SAN FRANCISCO PLANNING DEPARTMENT

Addendum to Environmental Impact Report

Addendum Date: December 11, 2013
Case No.: 2007.0946E
Project Title: Candlestick Point-Hunters Point Shipyard Phase II
EIR: 2007.0946E, certified June 3, 2010
Project Sponsor: CP Development Co., LP
Lead Agency: San Francisco Planning Department/Office of Community Investment and Infrastructure
Staff Contact: Chris Kern – (415) 575-9037
chris.kern@sfgov.org

FIGURE 2 – NON-STADIUM VARIANT 2A 2013 PHASING SCHEDULE

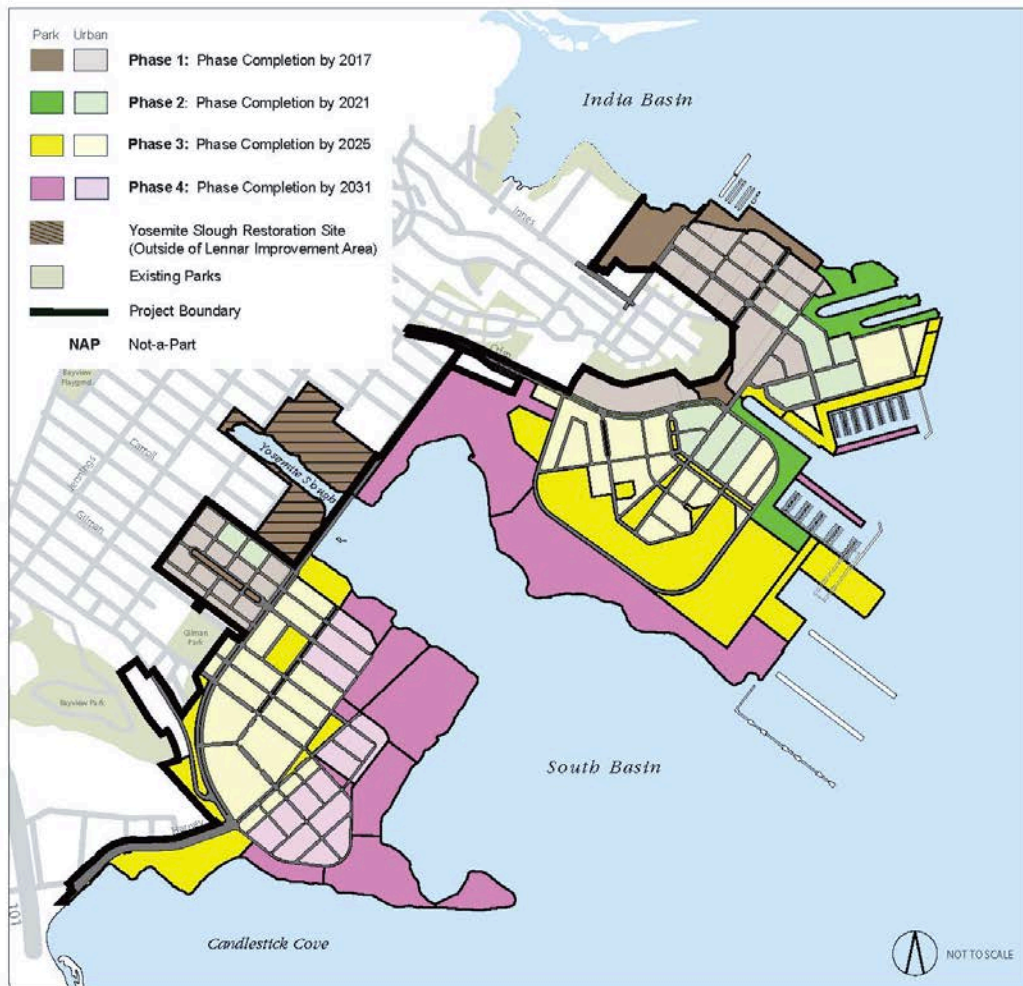
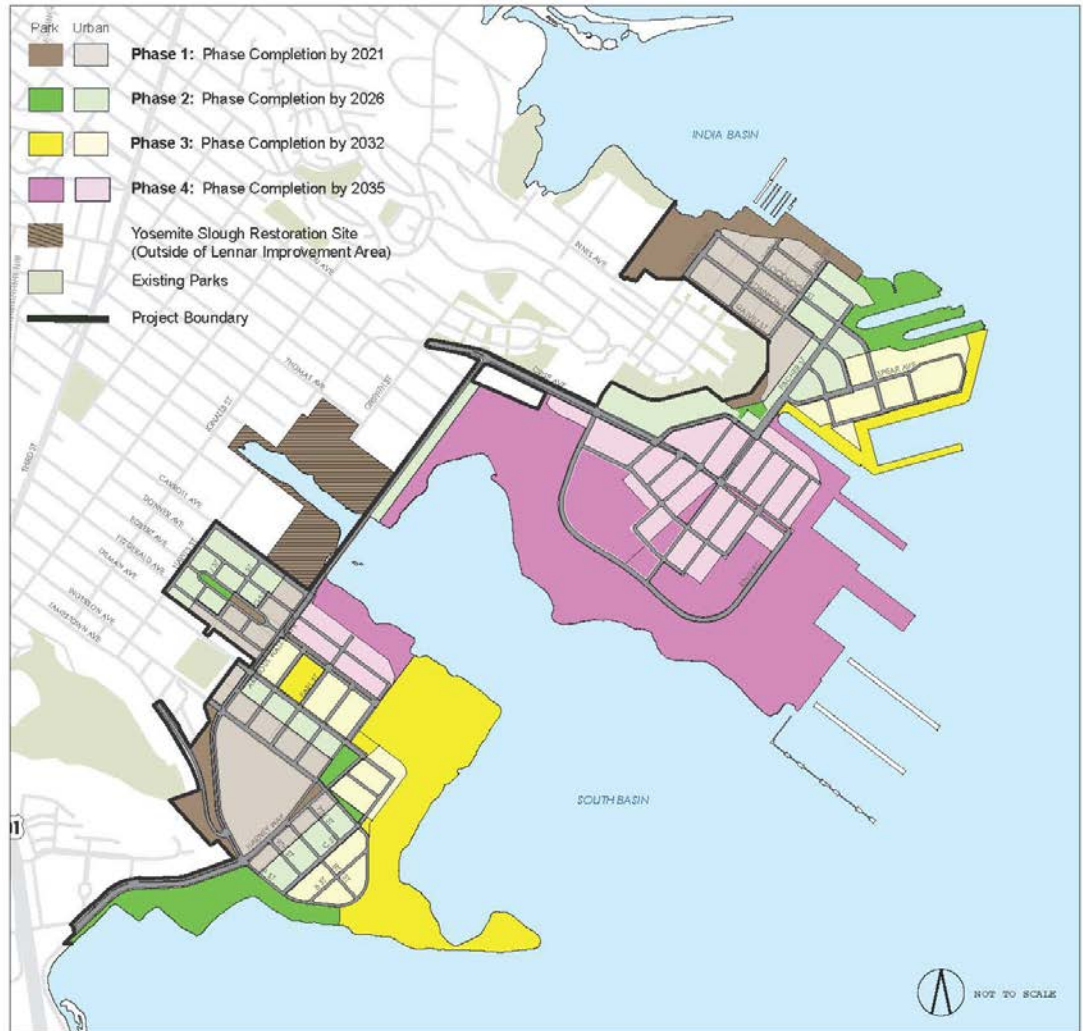
- Demolition of Candlestick Park stadium and construction of the Candlestick Point Regional Retail Center in Major Phase 1 instead of Major Phase 3 as shown in the 2010 Project Phasing Schedule.
- Development of all of the research and development blocks on Parcel C in HPS Phase II in Major Phase 3 instead of splitting this development between Major Phase 2 and 3 as shown in the 2010 Project Phasing Schedule.
- Development of all improvements in the HPS Phase II South area in Major Phase 4 instead of splitting this development among Major Phases 2, 3, and 4 as shown in the 2010 Project Phasing Schedule.

Tables 1-5 and **Figures 1 and 2** compare the 2010 Project Phasing Schedule with the proposed 2013 Project Phasing Schedule.

Figure 3

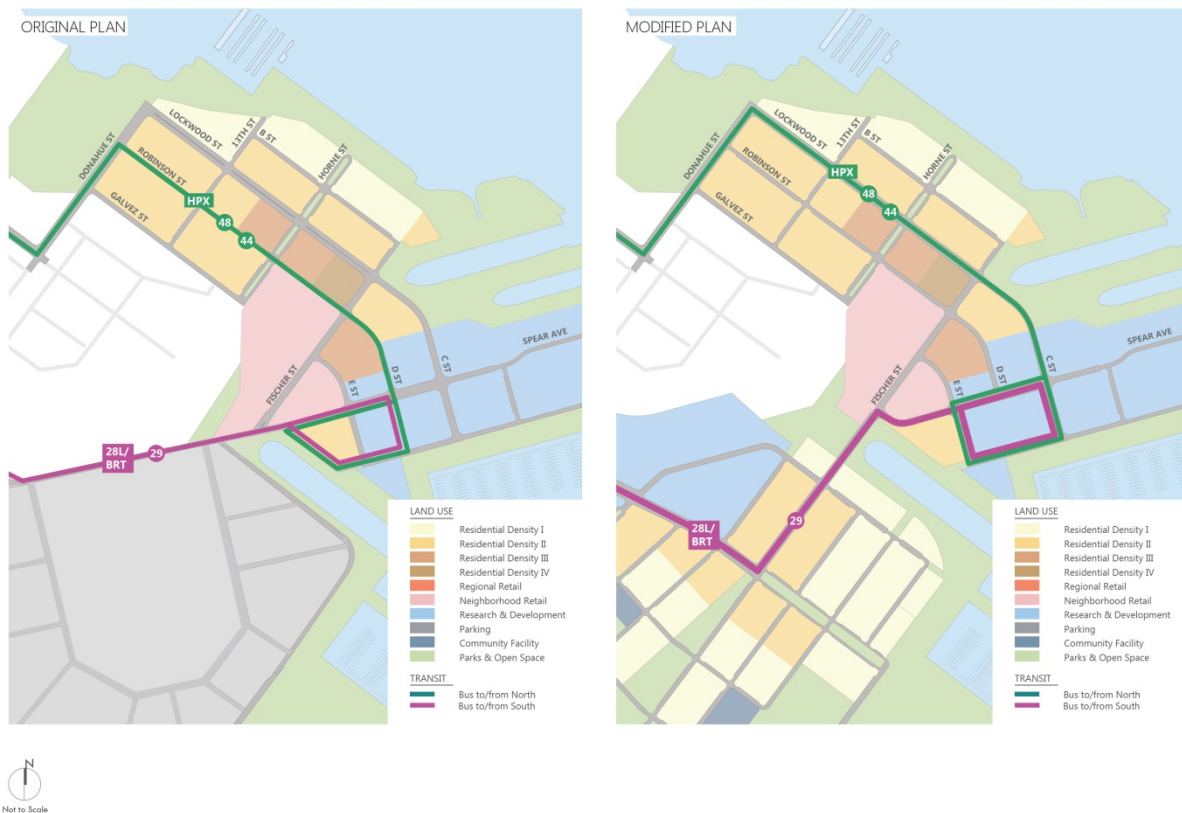
Figure 3 below illustrates the proposed change to the 29 Sunset routing within Candlestick Point. The Project as described in the FEIR called for the 29 Sunset to circulate within the Candlestick Point retail center. Under the proposed project modifications, the 29 Sunset would continue to serve the front of the retail center along Ingerson Avenue, but instead of circulating within the retail center, the route would circulate around the development blocks to the north, so that the 29 Sunset would provide more direct service to the high-density residential buildings proposed near the intersection of Gilman Avenue and Harney Way. This minor routing change is anticipated to increase the Project's transit mode share by bringing transit service closer to more residential units while continuing to provide direct "front-door" service to the retail center.

FIGURE 5 – COMPARISON OF TRANSIT SERVICE RELATIVE TO DEMAND DURING PROJECT BUILD OUT AT CANDLESTICK POINT

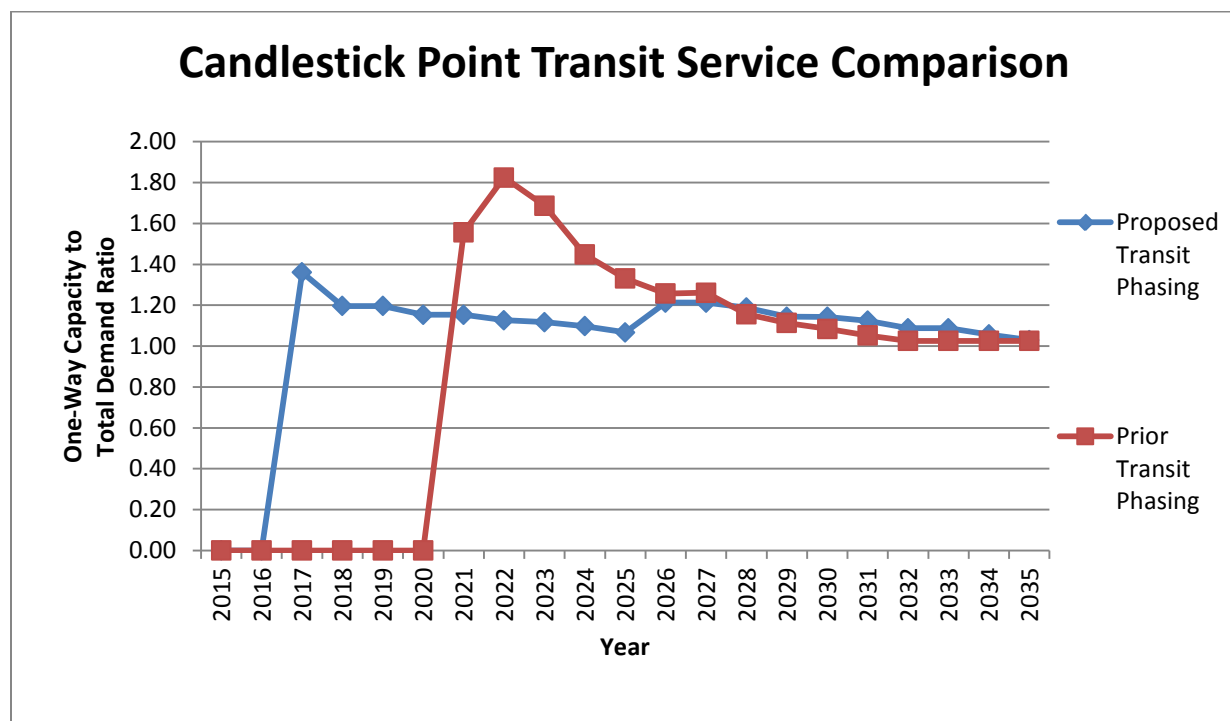
Figure 5 illustrates that with the revised development schedule and revised transit phasing, the level of transit service relative to demand would remain similar to or greater than the identified in the FEIR at build out. Thus, transit would remain an attractive option for travelers in the area.

FIGURE 6 – COMPARISON OF TRANSIT SERVICE RELATIVE TO DEMAND DURING PROJECT BUILD OUT AT HUNTERS POINT SHIPYARD

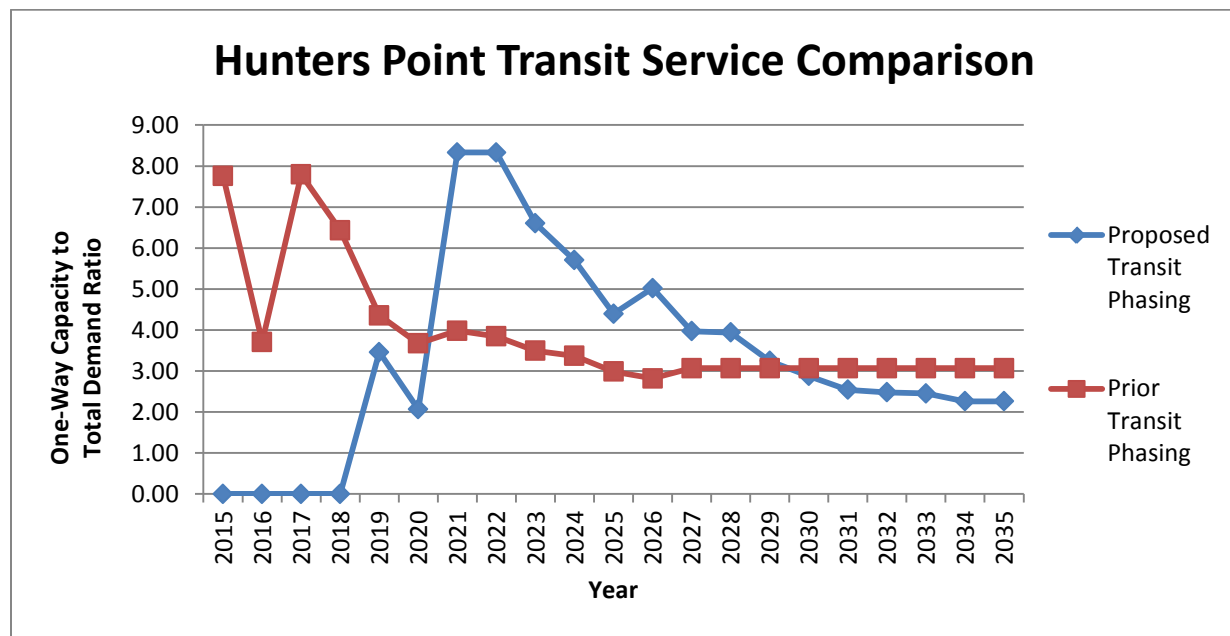
Figure 6 illustrates that once substantial development begins to occur in Hunters Point, the level of transit service relative to demand would exceed what was anticipated in the FEIR, based on the original development and transit implementation phasing until approximately year 2030. After that, the modified project appears to provide less transit service relative to demand than the original project is because the “original” project shown is the stadium alternative and the modified alternative is the Non-Stadium Alternative Variant 2A, which provides the same level of transit service with slightly higher demand than the Stadium Alternative. As a result, transit service would remain an equally attractive option in Hunters Point under the modified project development and transit phasing as was evaluated in the FEIR.
